**Subject: Addendum to Draft Landfills 8 and 10 Field Sampling Plan
Presidio of San Francisco, California**

Subject: Field Sampling Plan Addendum for Landfill 10 Trenching
Presidio Trust, San Francisco, California
(EKI A70004.07)

Landfill 10 Proposed Exploratory
Trench Locations

Presidio Trust
San Francisco, CA
October 2007
EKI A70004.07
Figure 2A

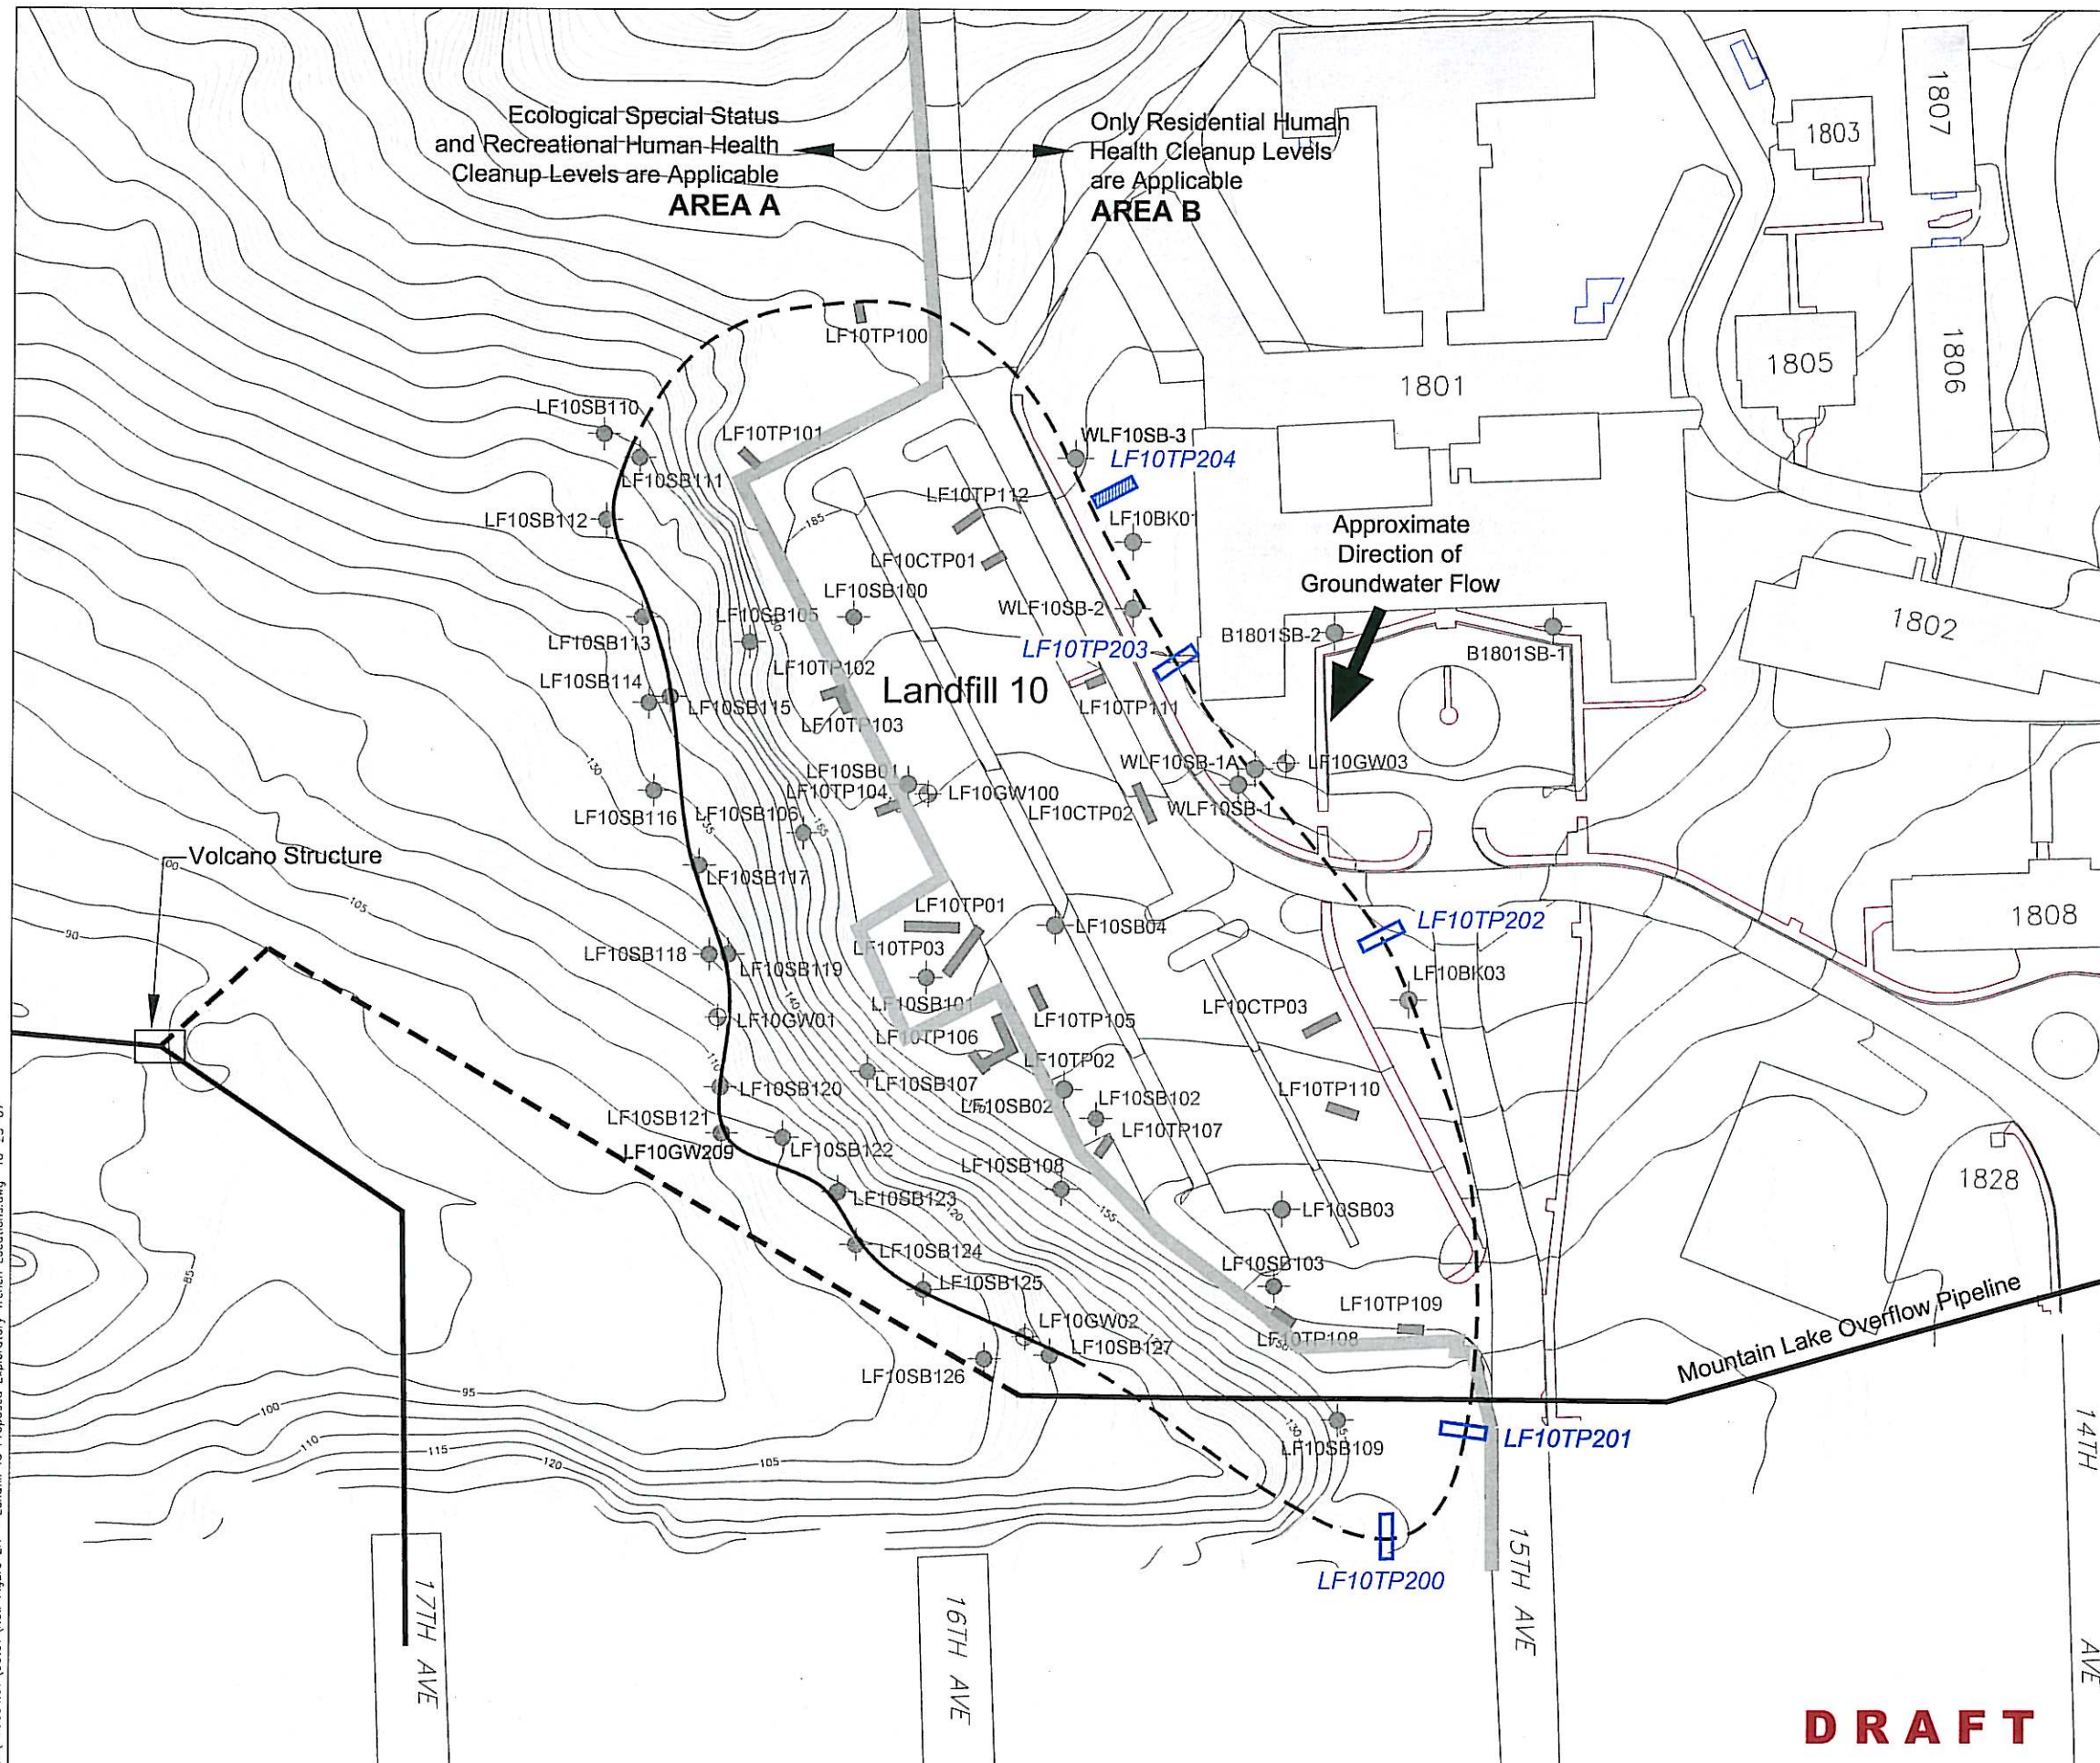
As shown on Figure 2A, up to five edge definition trenches (LF10TP200 through LF10TP204) are proposed for the southern and eastern edges of Landfill 10. The data quality objectives for the soil trenching at LF10 are presented in Table 2A. The trenching approach is similar to that described for Landfill 8 in Section 4.1.1 of the FSP. Trenches are intended to provide edge definition. Locations will be finalized in the field with representatives of the Trust and will depend upon the presence of surface, subsurface, and overhead obstructions, as well as site topography and accessibility. As shown in Table 4A, soil samples will be analyzed for metals, petroleum hydrocarbons, and polycyclic aromatic hydrocarbons, the identified chemicals of concern at Landfill 10.
